**SERVICE BULLETIN**

**N° 139-463**

**ATA 46 – INSTALLATION OF KIT CENTRAL DISPLAY**

This Service Bulletin is issued in order to provide the necessary instruction on how to perform the installation of the installation of the kit central display Sirio Panel P/N 4G4630F00312.

**Figure 2**

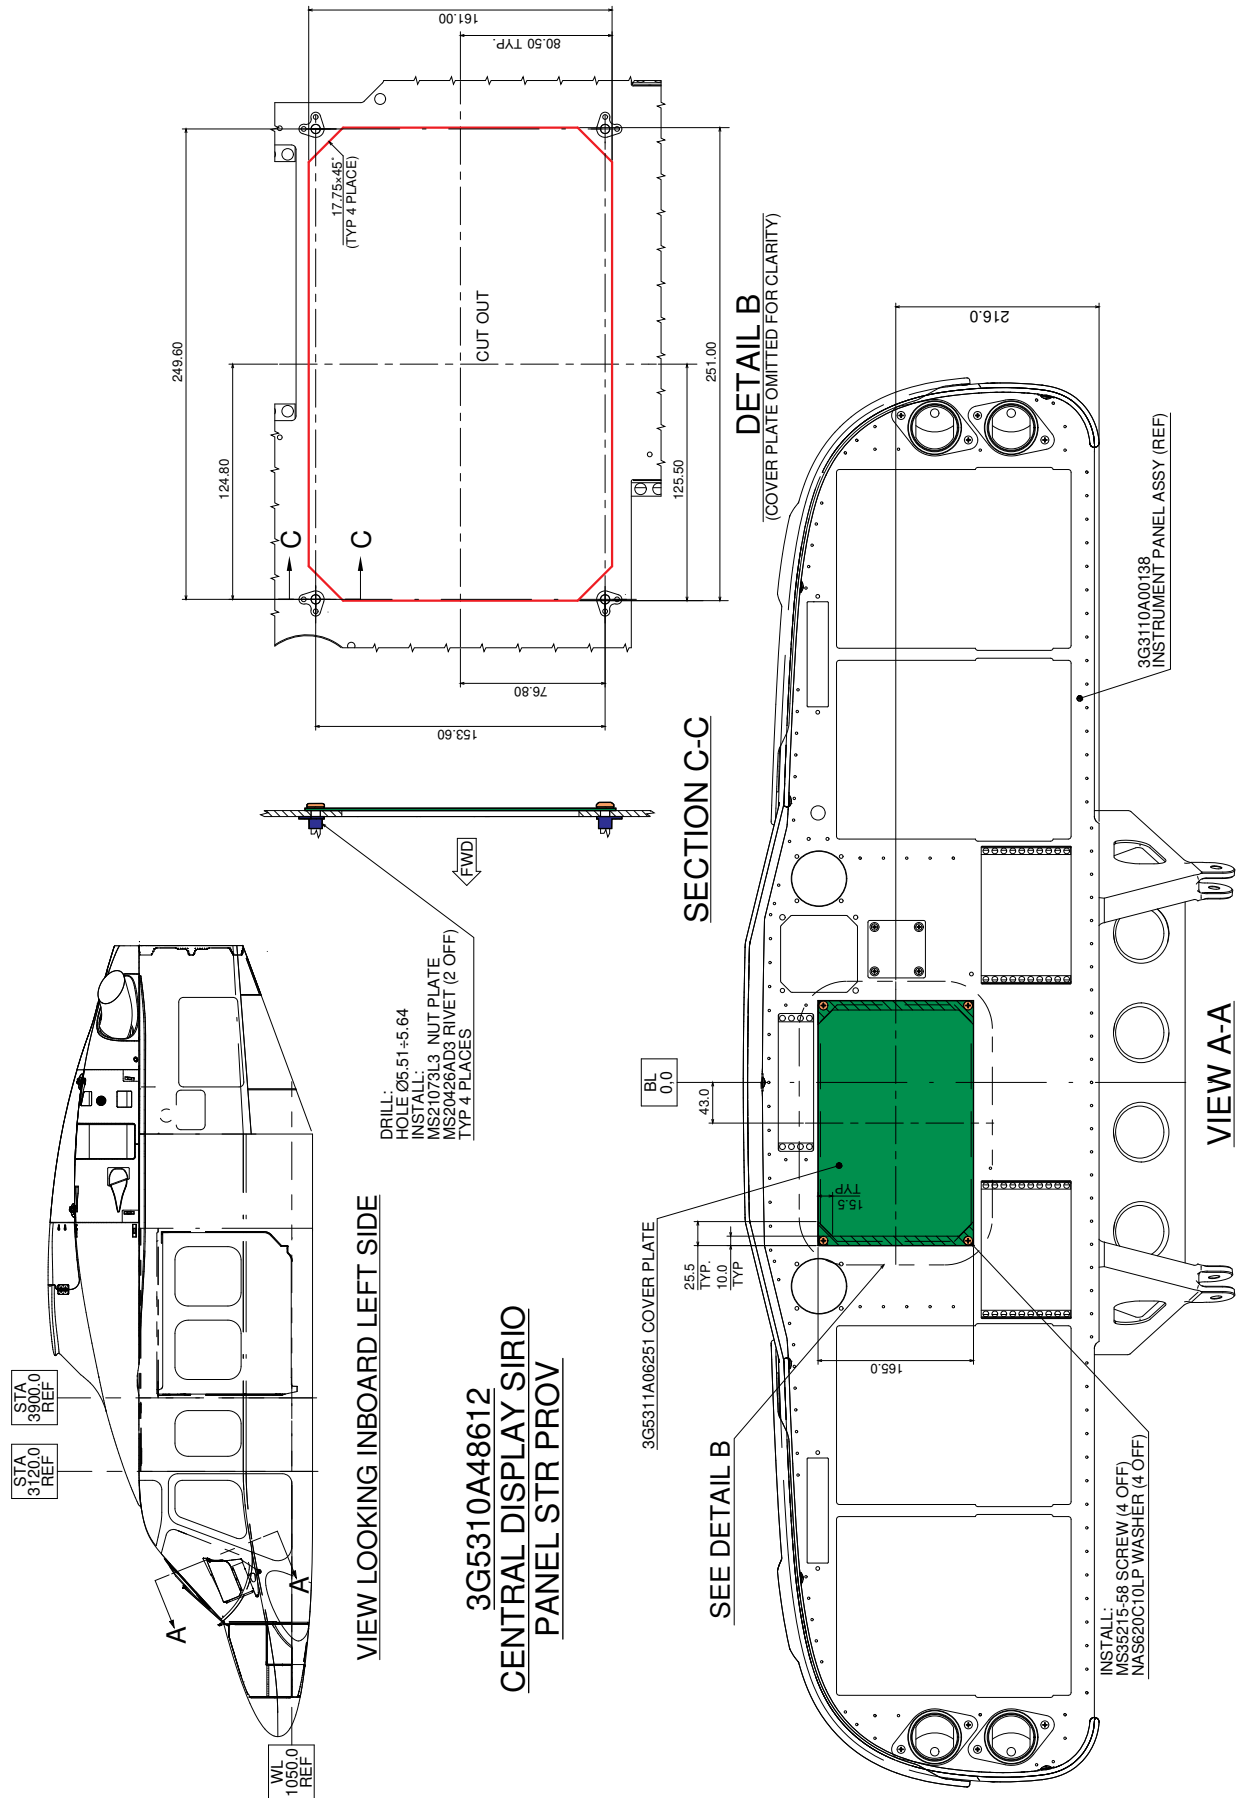
4. In accordance with AMP DM 39-A-25-82-03-00A-520A-A, remove the left hinged lining panel.
5. In accordance with AMP DM 39-B-31-11-02-00A-520A-A, remove the top cover instrument panel.
6. With reference to Figure 2, gain access to the area affected by the installation and perform the Central display Sirio Panel structural provision P/N 3G5310A48612 as described in the following procedure:
  - 6.1 With reference to Figure 2 detail B, perform the indicated cut-out on the instrument panel assy P/N 3G3110A00138.
  - 6.2 With reference to Figure 2 view A-A and detail B, temporarily locate cover plate P/N 3G5311A06251 and countermark positions of n°4 holes.
  - 6.3 With reference to Figure 2 section C-C, perform n°4 holes Ø5.51±5.64.
  - 6.4 With reference to Figure 2 section C-C, install n°4 nut plates P/N MS21073L3 by means of n°8 rivets P/N MS20426AD3.

- 6.5 With reference to Figure 2 view A-A, install cover plate P/N 3G5311A06251 by means of n°4 screws P/N MS35215-58 and n°4 washers P/N NAS620C10LP.
7. With reference to Figures 3, 4, 6 and 7, perform the Central display Sirio Panel electrical provision P/N 4G4630A00612 as described in the following procedure:
  - 7.1 With reference to Figure 4 view C-C locations n°1, 2 and 3, install n°3 electrical supports P/N AW001CL001-N6 at shown positions by means of adhesive Hysol EA9309.3NA (C021).

**Figure 3**

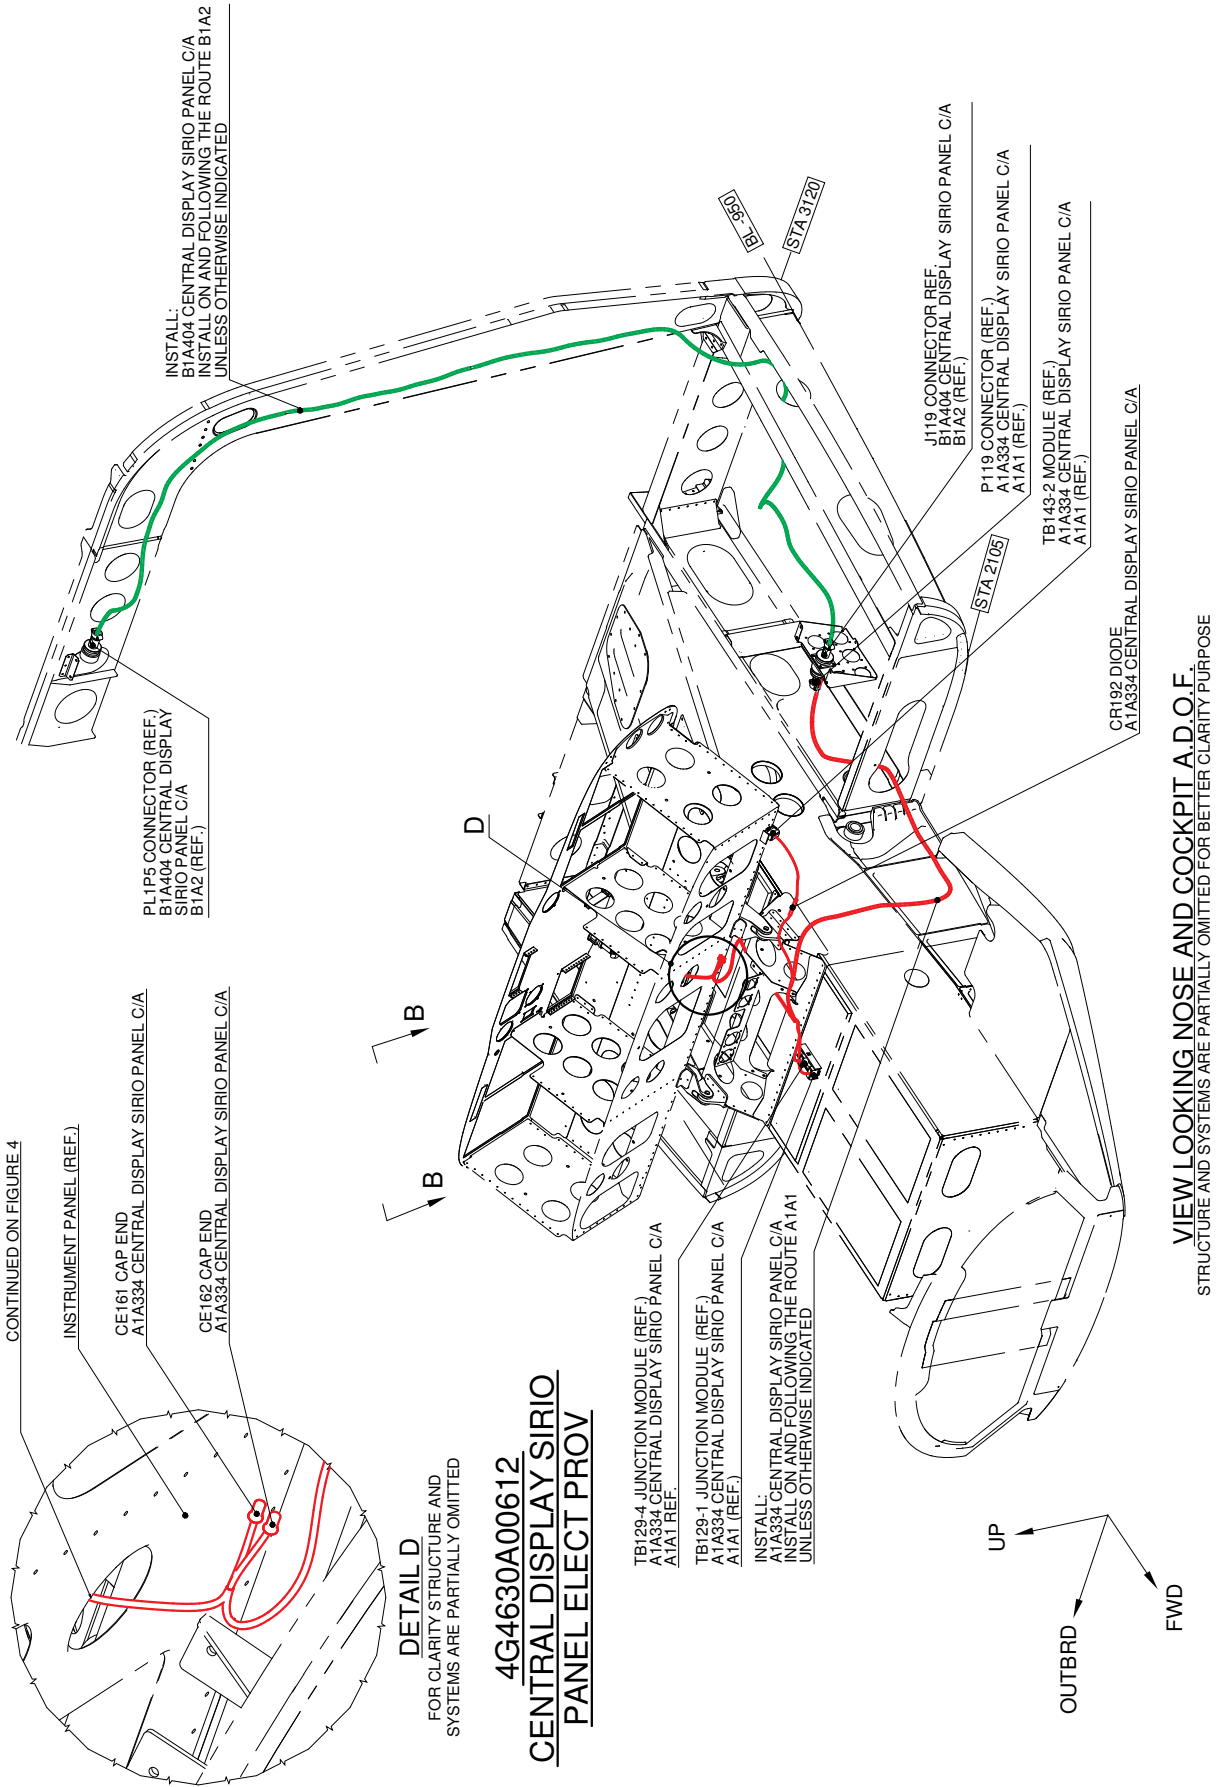
- 7.2 With reference to Figures 3 and 4, lay down the following cable assemblies:
  - 3G9A01A33401 display Sirio Panel C/A A1A334;
  - 3G9B01A40401 display Sirio Panel C/A B1A404.
- 7.3 With reference to Figure 3, to Figure 6 wiring diagram and to Figure 8, perform the electrical connection of cable Assy B1A404 between circuit breaker panel connector PL1P5 pin V and pin U and sectioning connector J119 pin X and pin N. Use electrical contact P/N M39029/56-352 for pin N of J119 and electrical contact

- 7.4 With reference to Figure 3, to Figure 6 wiring diagram and to Figure 8, perform the electrical connection of cable Assy A1A334 between sectioning connector P119 and central display connector A278P3 and between central display connector A278P2 and CE161.
- 7.5 With reference to Figure 3, to Figure 7 wiring diagram and to Figure 8, perform the electrical connection of cable Assy A1A334 between central display connector A278P3 and terminal boards TB143/2, TB129/4 and TB129/1 and between central display connector A278P1 and CE162.

Figure 4

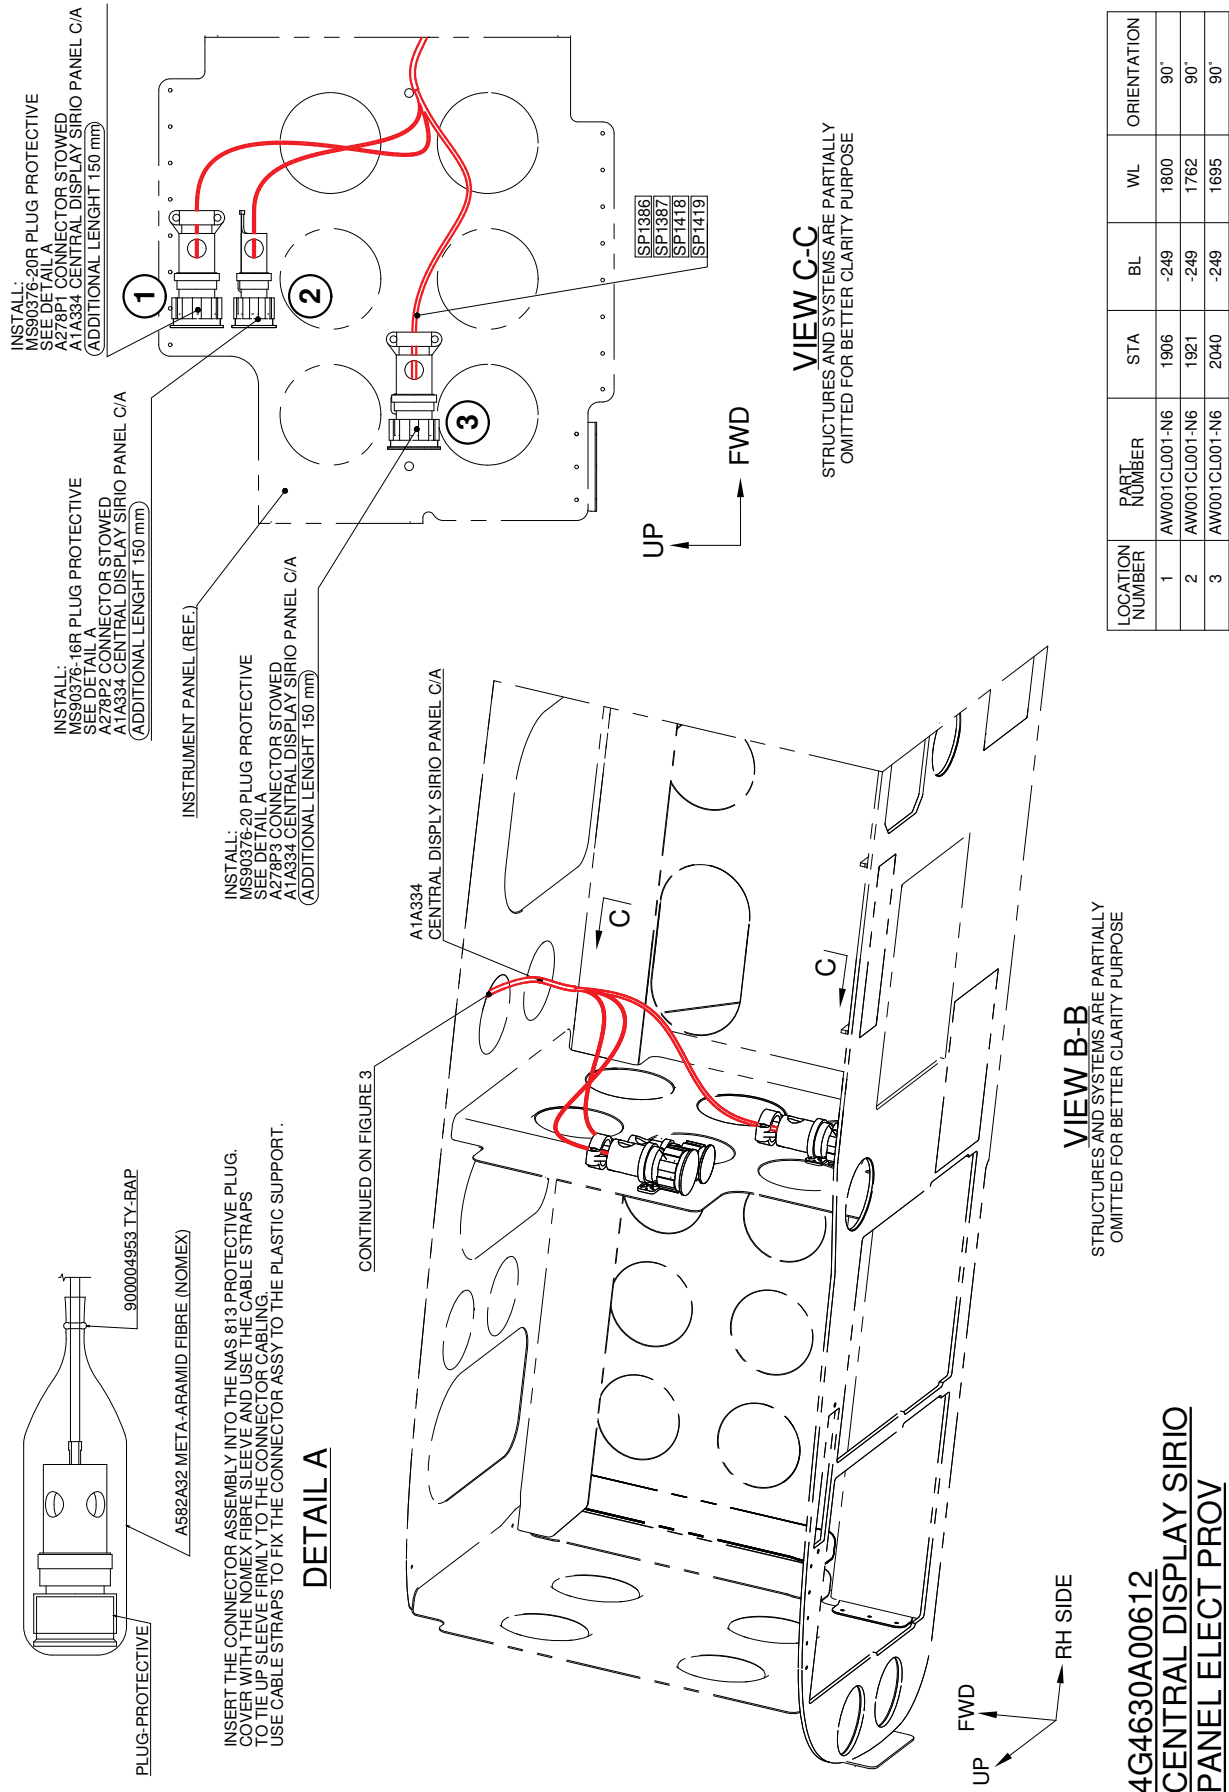
8. With reference to Figure 4 Detail A and view C-C, protect and stow the cable assemblies connectors A278P1, A278P2 and A278P3 as described in the following procedure:
  - 8.1 Apply the applicable protective cap P/N MS90376-16R on the connector assembly location n°2.
  - 8.2 Apply n°2 applicable protective cap P/N MS90376-20R on the connector assemblies locations n°1 and n°3.
  - 8.3 Cover with Nomex fibres sleeve P/N A582A32 and use tie straps P/N 900004953 to firmly tie down the sleeve on the connector.
  - 8.4 Fasten the connector with tie straps.
  - 8.5 Fasten the cable assemblies to the indicated supports.

**Figure 5**

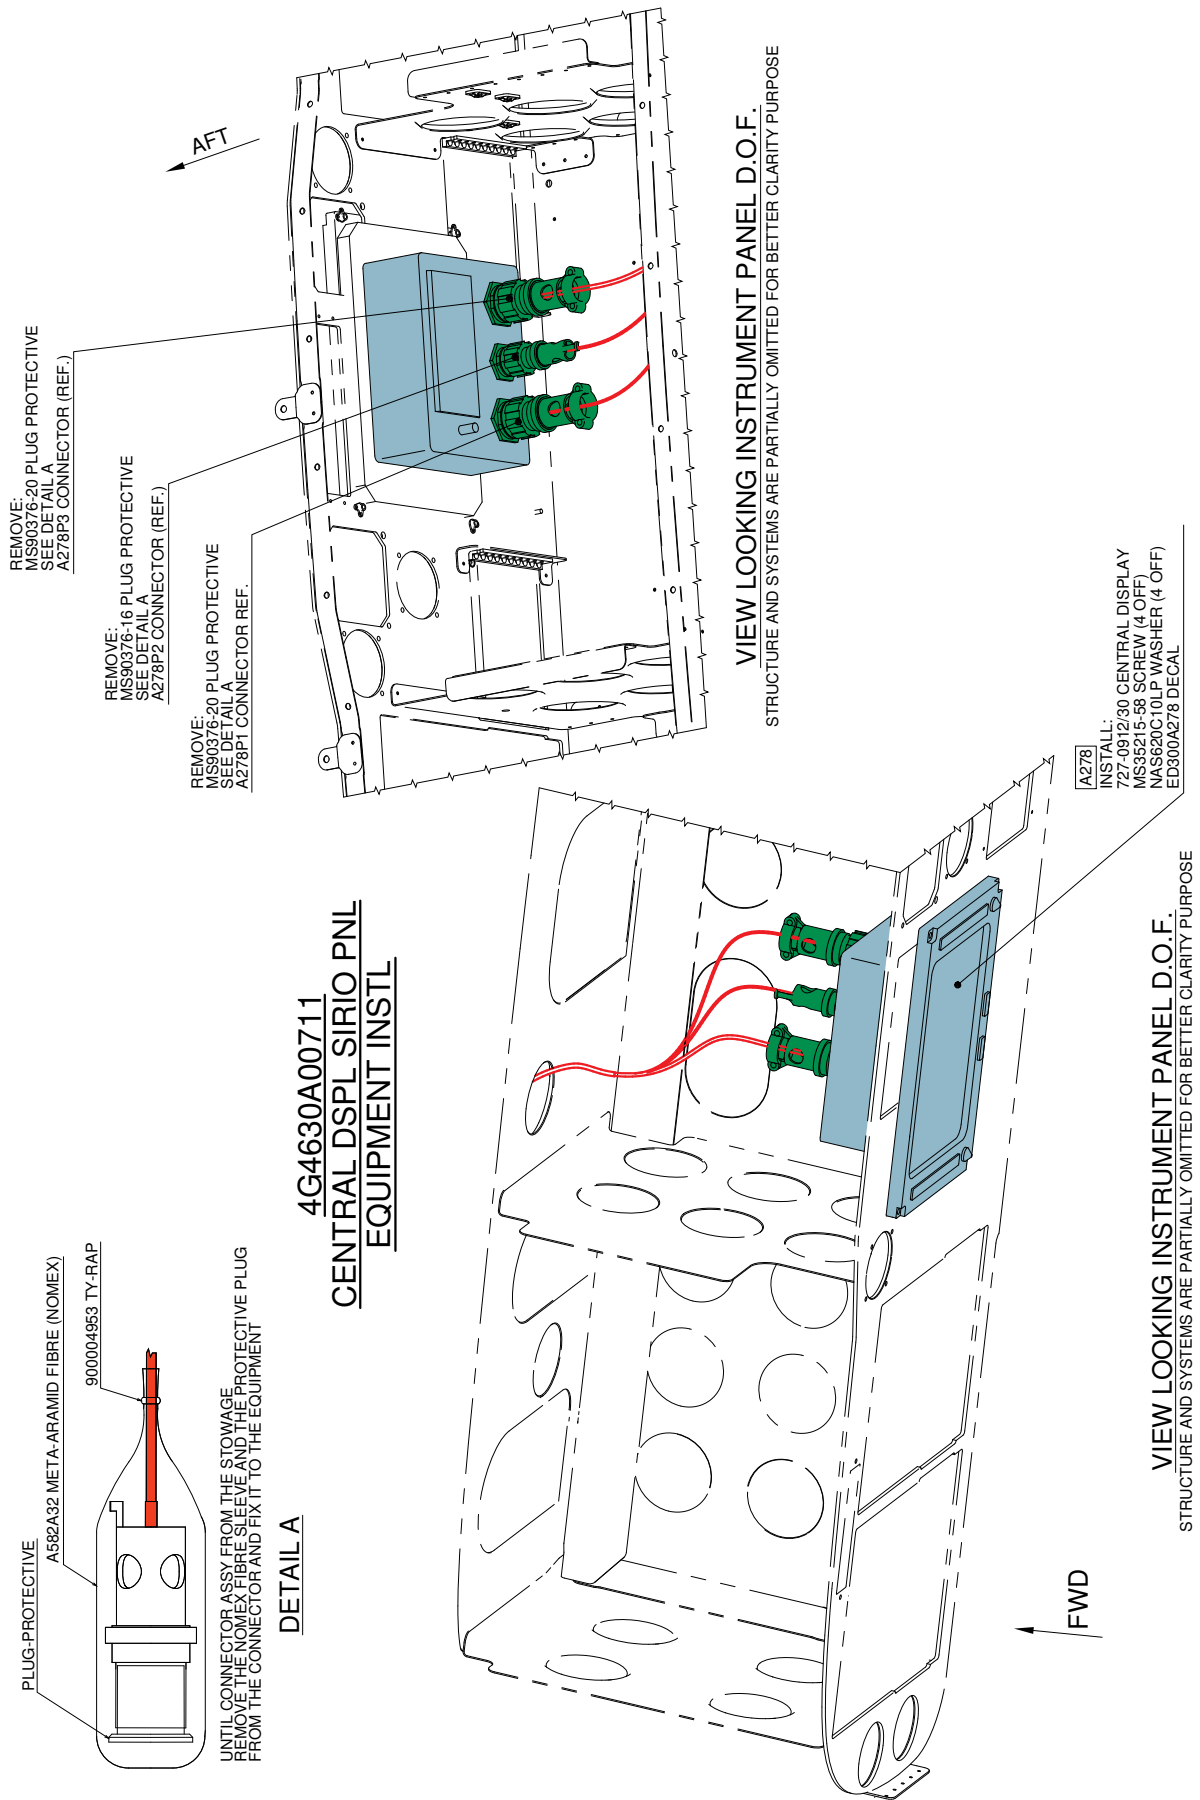
- 3.2 With reference to Figure 5 detail A and view looking instrument panel, prepare the connectors A278P1, A278P2 and A278P1 as described in the following procedure:

- 3.3 In accordance with AMP DM 39-U-46-32-01-00A-720A-A and with reference to Figure 5, install the central display SIRIO panel P/N 727-0912/30 by means of previously removed n°4 screws P/N MS35215-58 and n°4 washers P/N NAS620C10LP.

- 3.4 In accordance with AMP DM 39-A-11-00-01-00A-720A-A and with reference to Figure 5 view looking instrument panel, install in a visible area adjacent to the central display the decal P/N ED300A278.

4. Perform a pin-to-pin continuity check of all the electrical connections made.
5. With reference to Figure 5, perform the electrical connection of central display SIRIO panel P/N 727-0912/30 with cable assembly connectors A278P1, A278P2 and A278P3.
